November 16, 2011

WASTE TREATMENT AND IMMOBILIZATION PROJECT RESPONSE TO THE DEFENSE NUCLEAR FACILITIES SAFETY BOARD DESIGN OF AMMONIA CONTROLS

Figure 1: 2001 to 2010 Wind Speed Cumulative Distribution

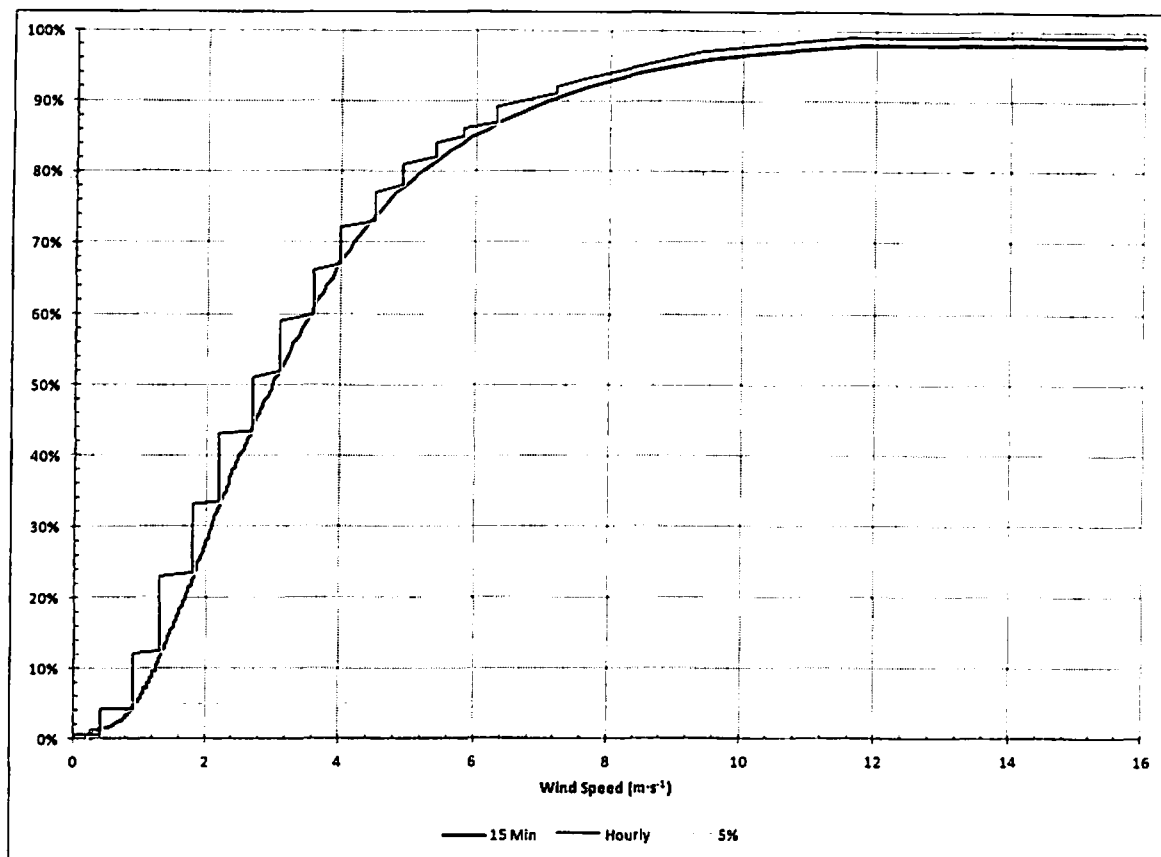
Calculation 24590-WTP-Z0C-W14T-00023 employs a puff-plume model to evaluate airborne ammonia dispersion using 10 years of hourly-averaged meteorological data obtained from the Hanford Weather Station (HWS). The Defense Nuclear Facilities Safety Board (Board) noted in its letter that because the ammonia puff duration is short, the wind speed

determined from hourly data may not be appropriate. To address this issue, the WTP has obtained 15-minute data for the last 10 years from the HWS and has determined the associated fifth percentile wind speeds. WTP has compared the 15-minute average wind speeds with those that had been based on hourly data. The results of this comparison for selected locations where ammonia releases could occur are shown in Table 1.

As can be seen, in all but one minor case, the 15-minute data yielded higher fifth percentile wind speeds, indicating that the original use of the hourly data was conservative and the one exception is on the order of a one percent difference. Because the ammonia puff release is a short-duration event, use of the 15-minute data is the more technically correct approach. Consequently, a forthcoming revision to the MCR habitability calculation 24590-WTP-Z0C-W14T-00023 will use the 15-minute Hanford 200 East Area meteorological data wind speeds for the short-term puff portion of the release. For the longer-term plume portion of an ammonia release, the hourly-averaged data will continue to be used.

The HWS determines hourly data by calculating a vector rather than a scalar average of the four 15-minute intervals in the hour, rounding the result to the nearest mile per hour. The effect of this can be seen in the cumulative distribution curve shown in Figure 1, where the rounded hourly data produces a jagged step curve that results in lower wind speeds than the smooth curve produced by the 15-minute data, and explains why data yields higher wind speeds.
